TRANSMITTAL OF RESPONSE TO COMMENTS FOR THE TENTATIVE WASTE DISCHARGE REQUIREMENTS - SCHOLL CANYON LANDFILL, 7721 NORTH FIGUEROA STREET, GLENDALE, CALIFORNIA (FILE NO. 60-117, GEOTRACKER GLOBAL ID L10009414153)

RESPONSE TO COMMENTS ON THE TENTATIVE WASTE DISCHARGE REQUIREMENTS COUNTY SANITATION DISTRICTS OF LOS ANGELES COUNTY SCHOLL CANYON LANDFILL

FIGURE A-1:
EXISTING COMPLIANCE GROUNDWATER MONITORING LOCATIONS

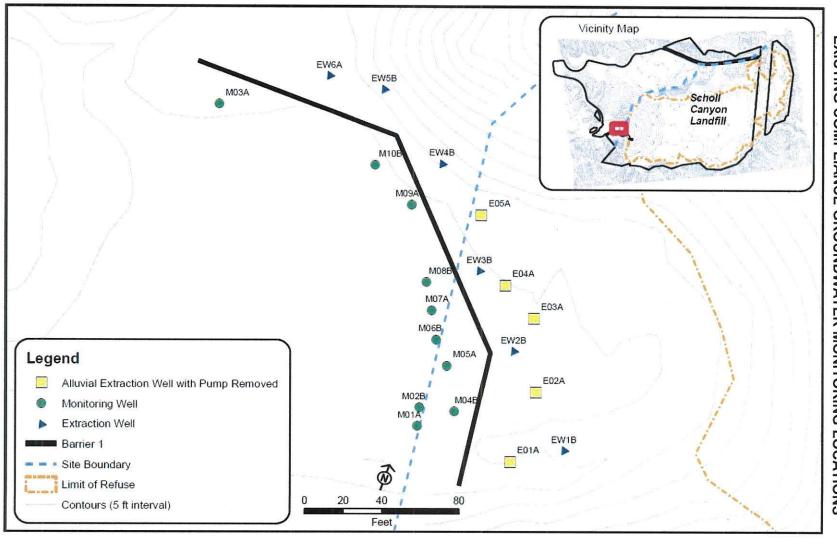
No.	Comment	Response	Action Taken
11	Regarding Section C.1 of the tentative MRP Section C.1 of the MRP indicates the Sanitation Districts are required to conduct analytical monitoring of leachate and the vadose (unsaturated) zone at the Landfill. Currently, Scholl Canyon Landfill does not have a leachate collection and recovery system (LCRS). In addition, sampling of soil pore liquids from the vadose zone is not required. The existing permit states that vadose zone monitoring can be eliminated when undergoing a corrective action program. The Sanitation Districts request the Regional Board consider revising this section as follows: 1. Environmental Monitoring Networks The Discharger shall conduct analytical monitoring of groundwater, and surface water, leachate, and the vadose (unsaturated) zone at the Landfill. The current environmental monitoring points for the Landfill are summarized in Table A-1 and their locations are displayed on Figures A-1 and Figure A-2.	The Board agrees.	The requirement is modified as requested.

No.	Comment	Response	Action Taken
MRP-2	Regarding Section B.2. of the tentative MRP As discussed, the Sanitation Districts request an extension of the deadline for submitting semi-annual and annual monitoring reports to the end of February and August each year. The Discharger shall submit an annual summary report to the Regional Water Board no later than February 28 January 31 of each year covering the previous monitoring year, which starts January 1 and ends December 31. This report may be combined with the semi-annual report that is due on February 28 January 31 of each year. The annual summary report shall include at least the following:	See response to Comment No. 5	
MRP-3	Regarding Section C.1 of the tentative MRP SCLF does not currently have an LCRS. Please delete the reference to leachate. Also, soil pore liquid monitoring of the vadose zone is not required at the landfill. The existing SCLF permit indicates "Vadose zone monitoring may be eliminated when undergoing a corrective action program". Please consider the following revisions: 1. Environmental Monitoring Networks The Discharger shall conduct analytical monitoring of groundwater, and surface water, leachate, and the vadose (unsaturated) zone at the Landfill. The current environmental monitoring points for the Landfill are summarized in Table A-1 and their locations are displayed on Figures A-1 and Figure A-2.	See response to Comment No. 11	de

The Discharger shall conduct analytical monitoring of groundwater, <u>and</u> surface water, <u>leachate</u>, <u>and the vadose (unsaturated) zone</u> at the Landfill. The current environmental monitoring points for the Landfill are summarized in Table A-1 and their locations are displayed on Figures A-1 and Figure A-2.
